Item Name: Crosstube Turning Detail

DART AEROSPACE LTD	Work Order:	112786
Description: Crosstube Assembly	Part Number:	D407-667-145
Inspection Dwg: D407-667-145 Rev: C		Page 1 of 2

DRAWING NO. D407-667-145	TITLE CROSSTUBE ASS'Y (407 HIGH FWD)	REV. C	DART AEROSPACE LTD ENGINEERING ORDER		D.E.O. NO. D407-667-145-C-1	SHEET NO. SHEET 1 OF 1	SCALE NTS
DRAWN <i>qp</i>	CHECKED <i>ASS</i>	MFG. APPR. <i>AB</i>	APPROVED <i>WD</i>		DE APPR. <i>HA</i>		
DATE 11.07.15	DATE 11.07.22	DATE 11.07.22	DATE 11/07/22		DATE 11.07.21

DETAIL P
BONDING STRAP INSTALLATION 2 PL

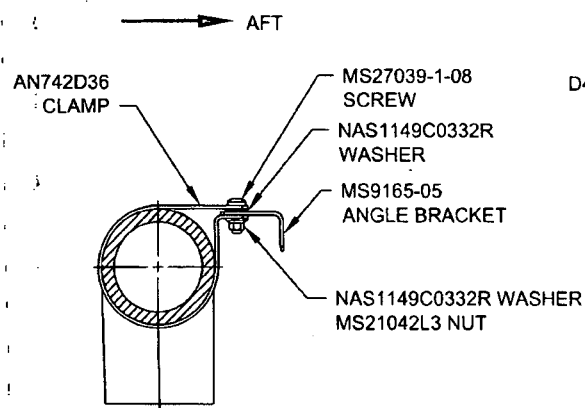
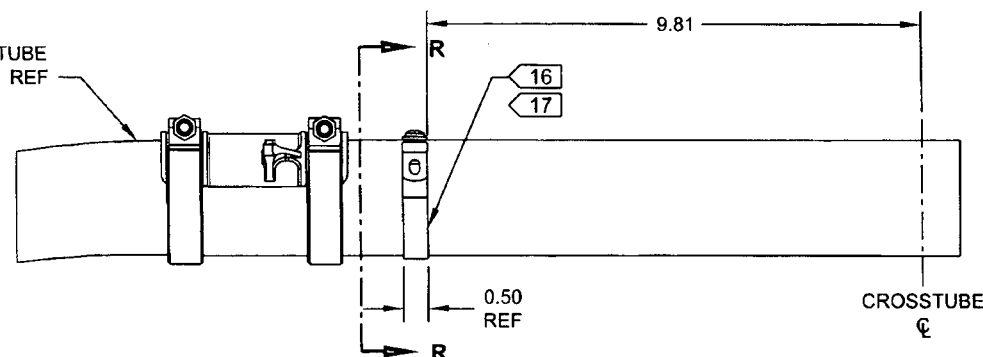
ADD ELECTRICAL GROUNDING STRAP

ITEM	QTY -145	PART NUMBER	DESCRIPTION
1	X	D407-667-145	CROSSTUBE ASSEMBLY (407 HIGH FWD)
10	2	AN742D36	CLAMP
11	2	MS9165-05	ANGLE BRACKET
12	2	MS21042L3	NUT (OR MS21042-3)
13	2	MS27039-1-08	SCREW
14	4	NAS1149C0332R	WASHER (OR AN960C10L)

- 16) MASK AREA UNDER CLAMP PRIOR TO PAINTING
- 17) SEAL EDGES WHERE AN742D36 CLAMP MEETS WITH THE CROSSTUBE USING SIKAFLEX-241/-291 OR MIL-S-8802 CLASS B2 OR PROSEAL 890 SEALANT
- 18) PERFORM RESISTANCE CHECK TO ENSURE MAX RESISTANCE IS 10 MILLIOHMS
